Adams School Redevelopment

Addendum No. 4 to Contract Documents

April 12, 2012

ADAMS SCHOOL REDEVELOPMENT

temporary construction sign for CDBG projects

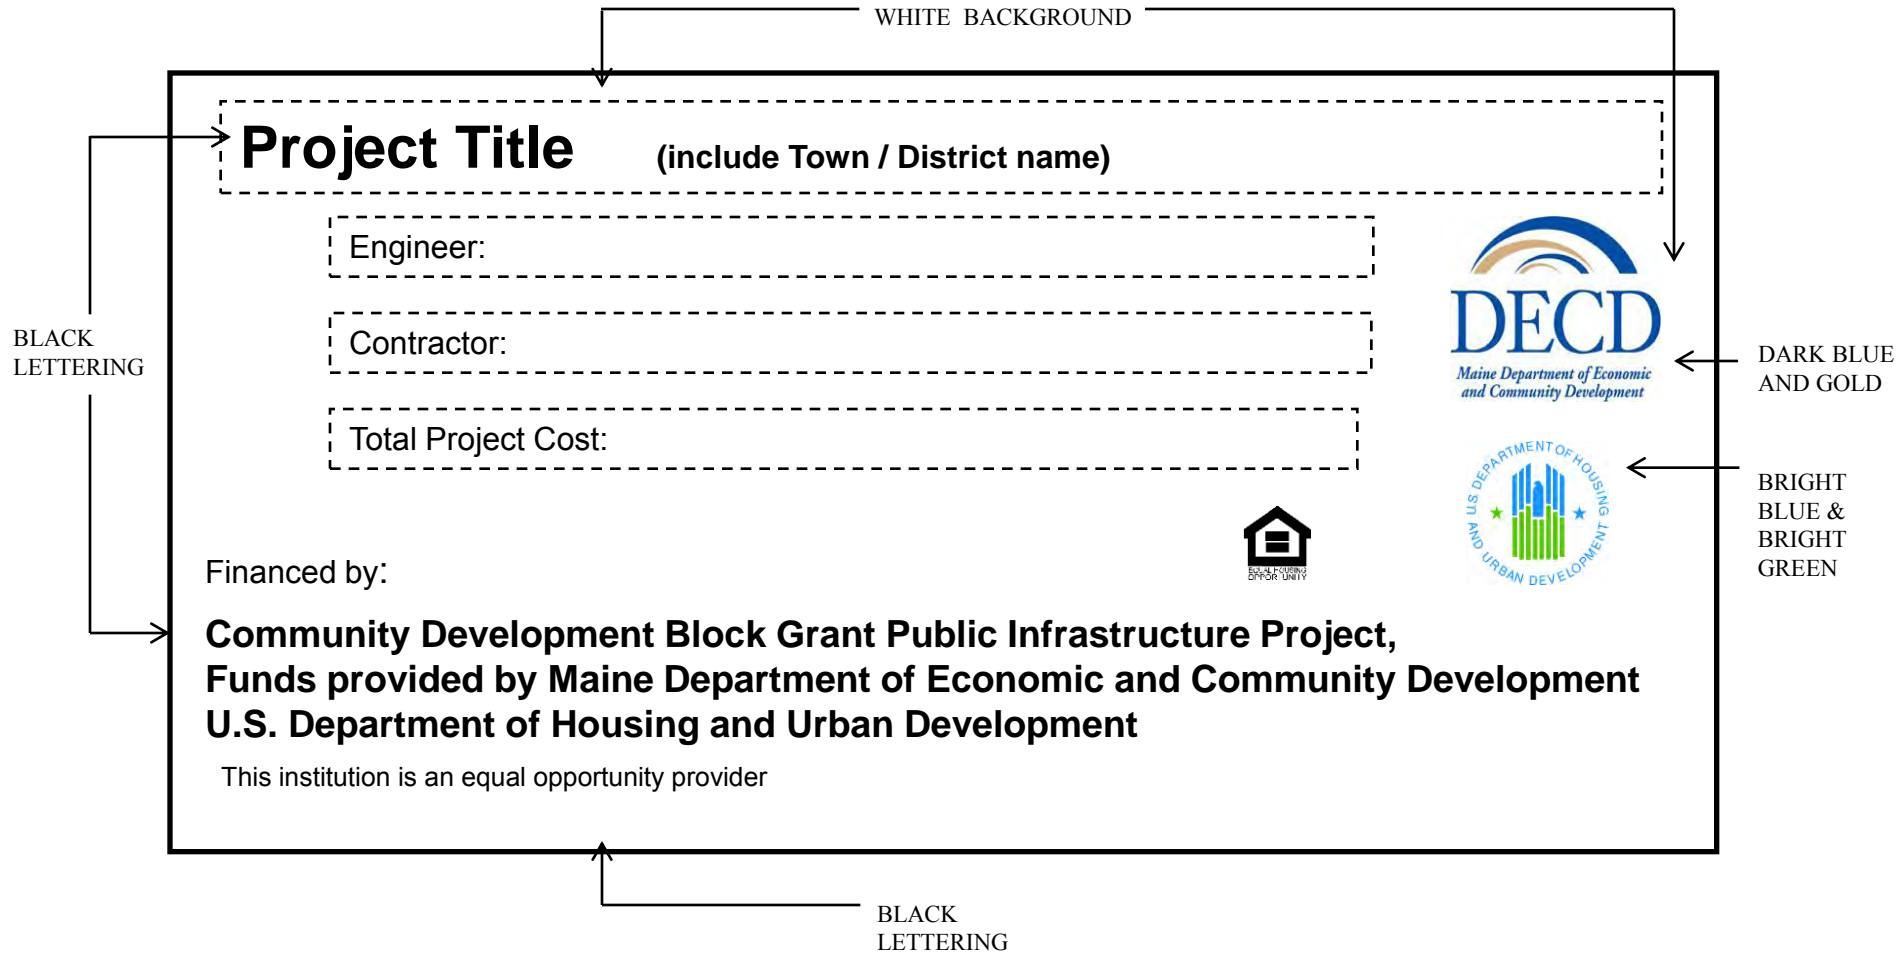
REPLACE sign graphic with attached sign graphic (*omitted from Addendum 2*). NOTE that this sign is IN ADDITION to the temporary sign specified in 015000/3.3.F.

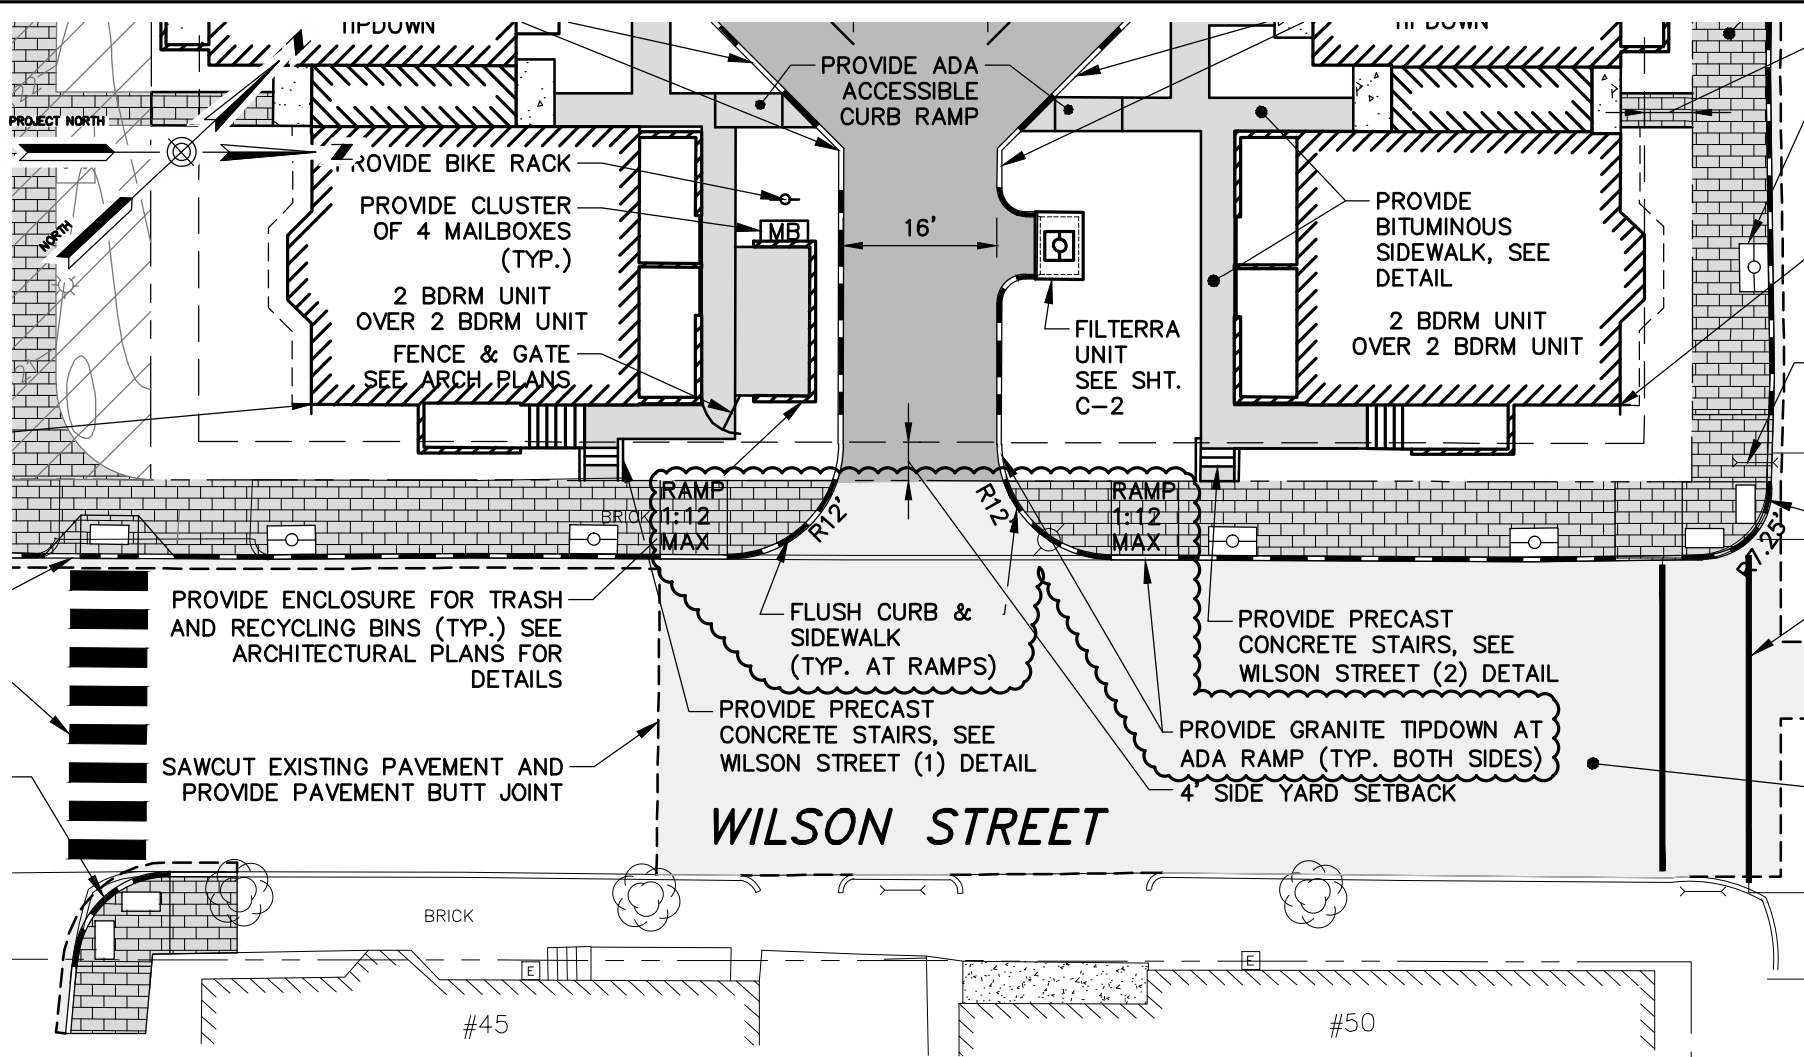
- A. SHEET C-2: Modify as shown on attached SK-1 and SK-2.
